Meeting Date:
October 13, 2025

Location:
41 E. Main Street

Request:
Major Site Plan

Hudson Planning Commission	SITE PLAN REVIEW – VILLAGE DENTAL
Case No. 25-1022	October 13, 2025

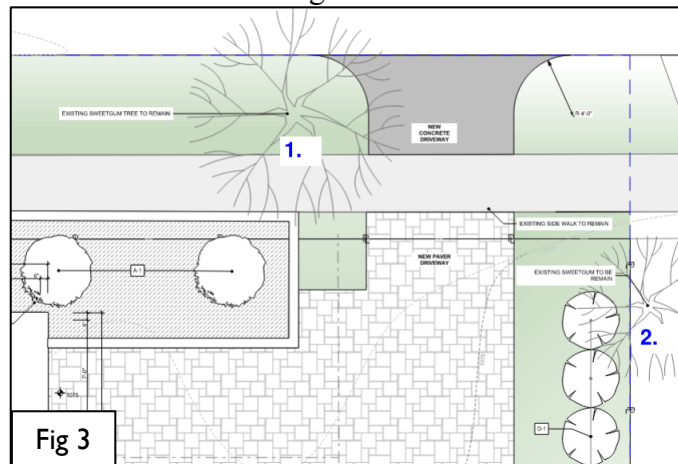
1. If the proposed improvements are made to the site, the existing mature red oak located within the city right of way (identified as a Sweetgum Tree on the plans) would be compromised (Location marked as #1 in Figure 3 below). The tree measures 33" DBH and 36" diameter-at-base and is estimated to be 65 feet tall. The structural root zone (SRZ) is calculated to be 9' radius. No buttress roots within this SRZ shall be severed as it put the tree at risk of failure. Additionally, the tree protection zone (TPZ) would be, at minimum, 49-foot radius. Any cuts, fills, compaction, or otherwise damage to roots within this TPZ could compromise the tree's health and cause decline.

2. Additionally, there is a Sweetgum located on the adjacent parcel that could be affected by the proposed development (Location marked as #2 in Figure 3 below). The proposed area of disturbance falls within the TPZ but not the SRZ. Any damage to roots within the TPZ would potentially lead to a decline in health for the sweetgum.

Staff notes the proposed concrete drive apron is proposed directly adjacent to the mature street tree. Staff has previously recommended the applicant explore the feasibility of entering into a shared access agreement to utilize the neighboring drive to the east. Such would reduce the total number of adjacent curb cuts and potentially protect the mature street tree. Question if the applicant has explored this possibility. Additionally, the applicant should provide additional documentation/protection measures for the adjacent Sweetgum tree.

3. Provide additional documentation regarding protection measures for the existing Sweetgum tree identified in Figure 3 of this report.
4. Revise the landscaping drawings to incorporate evergreens along the eastern property line.

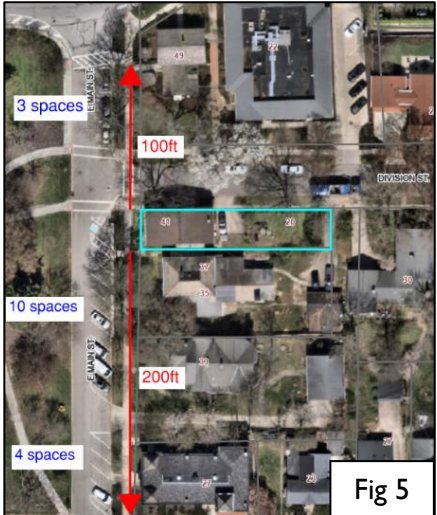
Staff notes existing landscaping would be removed along the eastern property line depicted in Figure 4 below. This landscaping would be replaced by 6 Korean Spice Viburnums. Staff recommends evergreens be planted in lieu or in addition to the viburnums to help buffer the adjacent residential homes to the east.
